RCRBD
Record Set
TC
04/24/2020

HAYDEN GRANARY ROOF
198 E LINCOLN AVE
HAYDEN, COLORADO
A STRUCTURAL UPGRADE FOR:
HAYDEN GRANARY

PLAN VIEW &
STRUCTURAL
NOTES

S-1

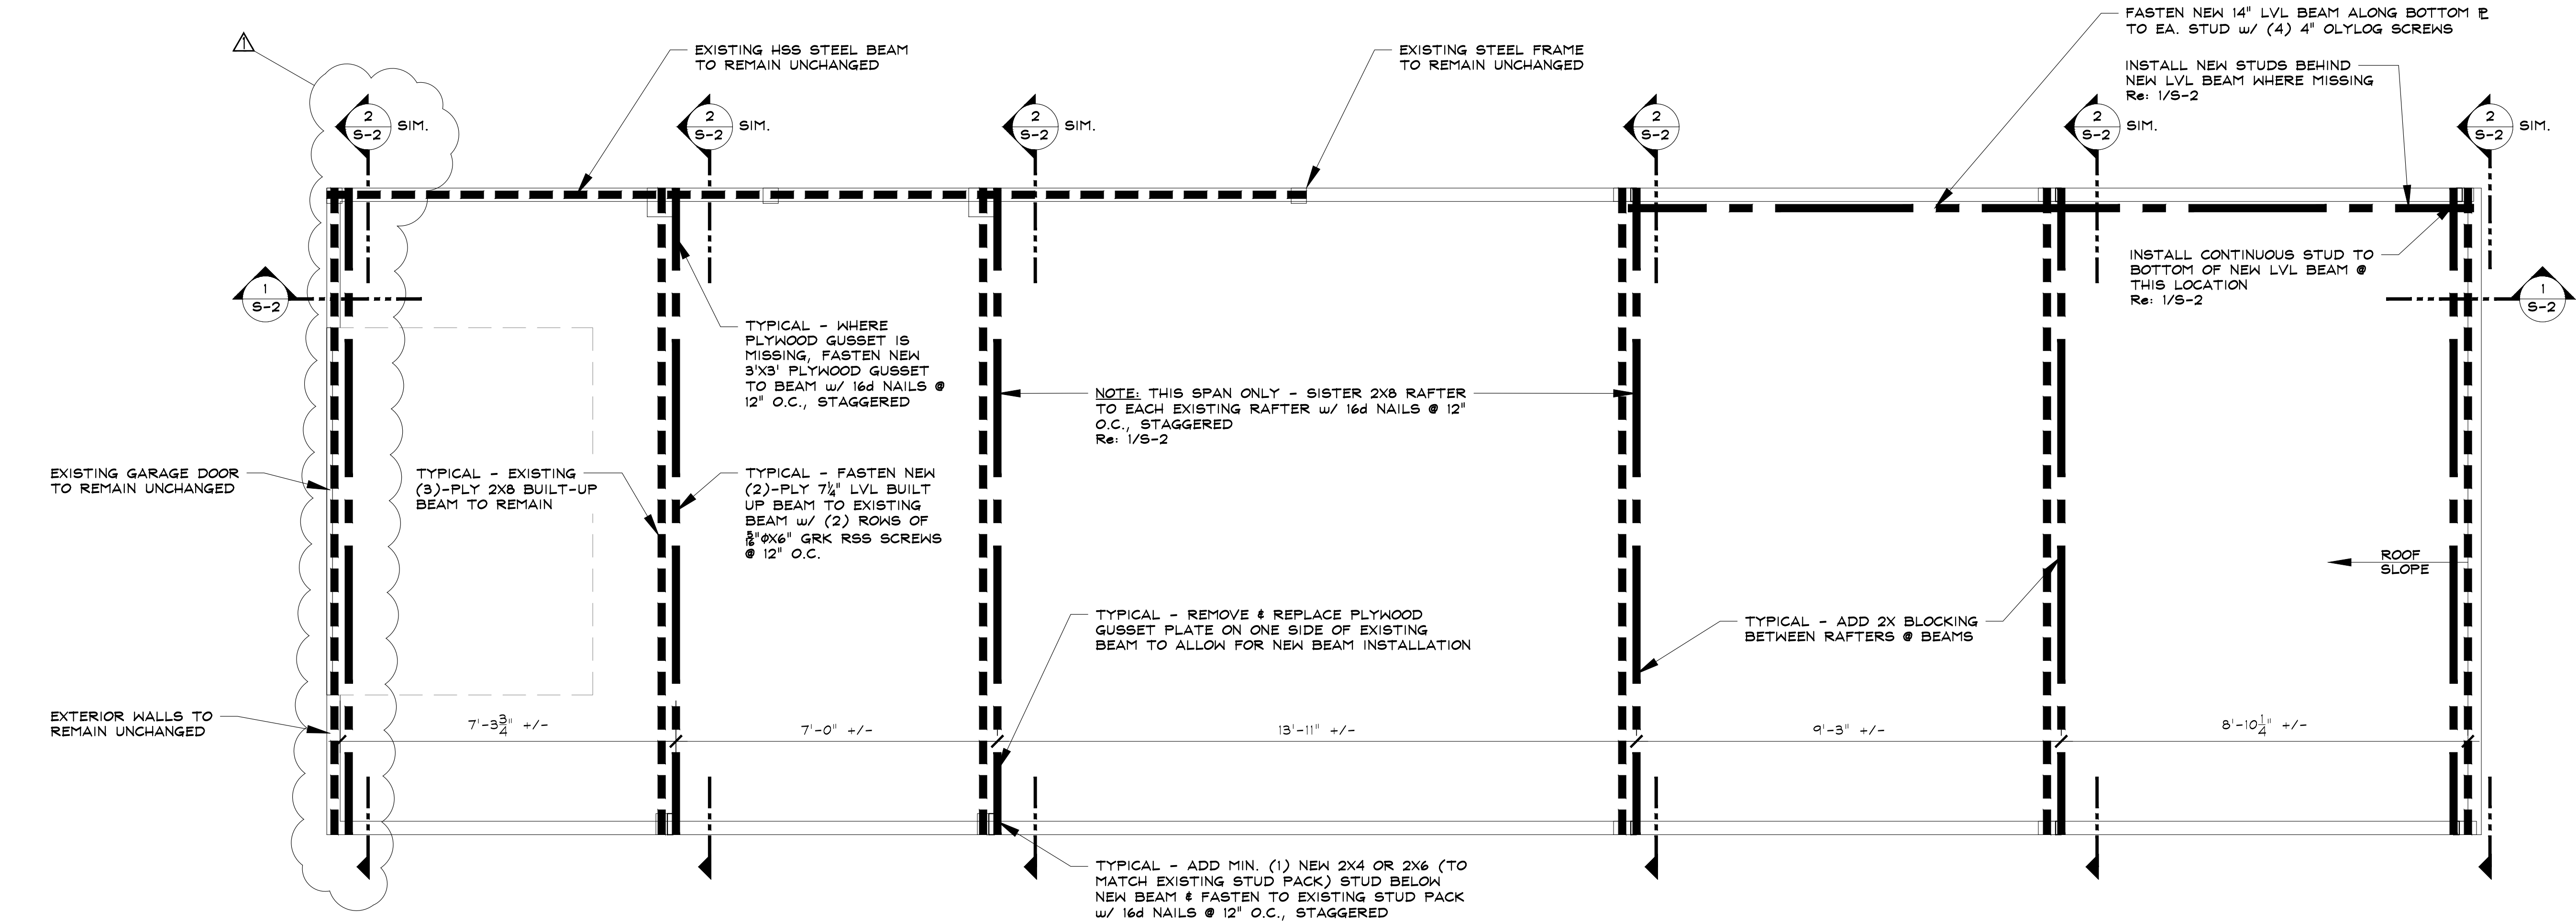
2015 ICC
Codes are
applicable

RCRBD Comment:This Permit is approved for Structural Improvements to the existing framing members inside the building only, and this approval does not include any; Interior Ceiling or Wall Coverings, No Insulation, No Electrical, Plumbing or Mechanical Work.

Work does include new Roofing Underlayment and Roofing Materials.

S-2

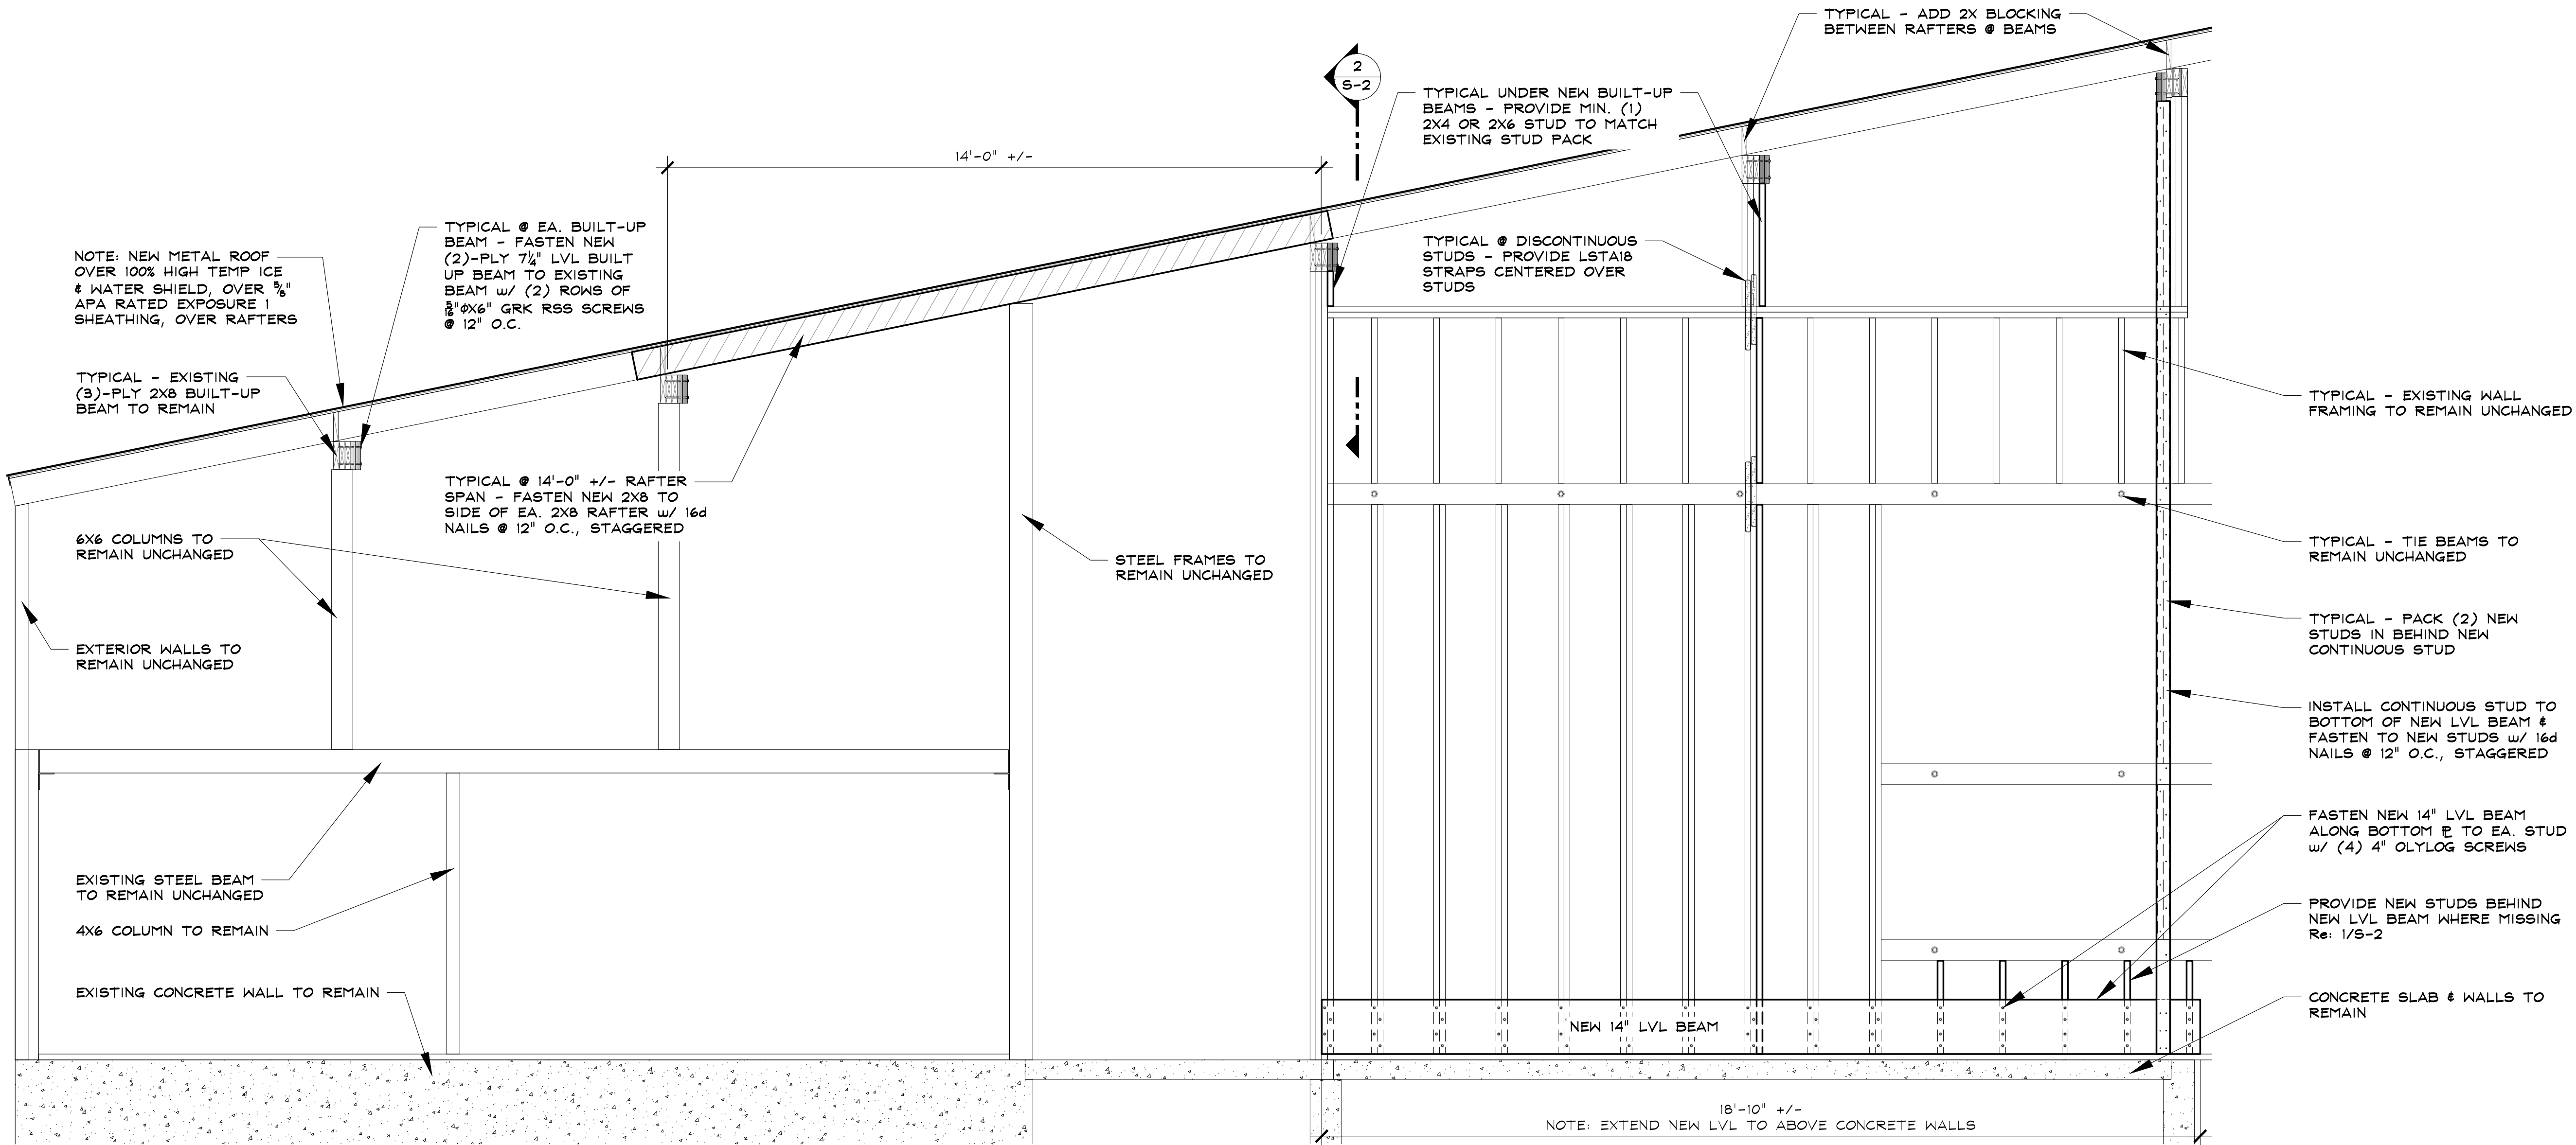
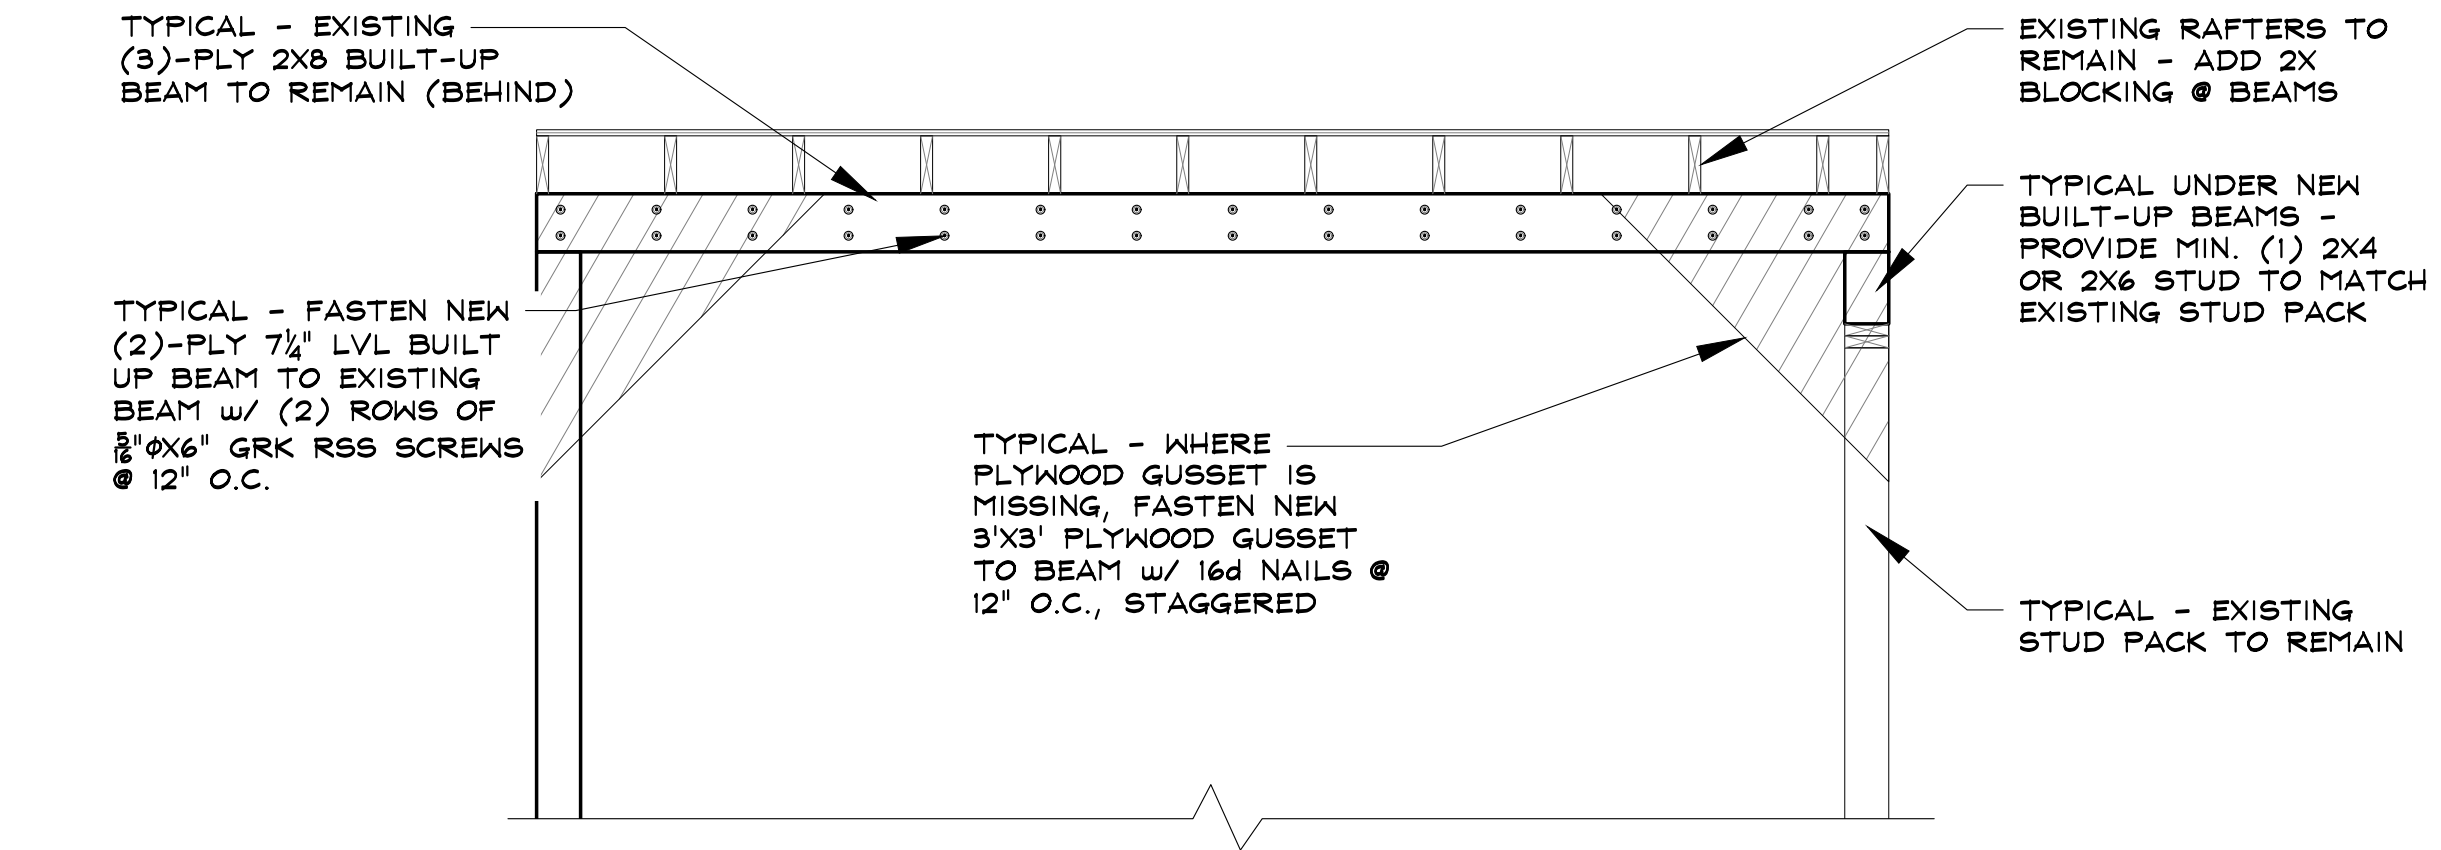
RCRBD Comment: This Permit is approved for Structural Improvements to the existing framing members inside the building only, and this approval does not include any; Interior Ceiling or Wall Coverings, No Insulation, No Electrical, Plumbing or Mechanical Work.

Work does include new Roofing Underlayment and Roofing Materials.
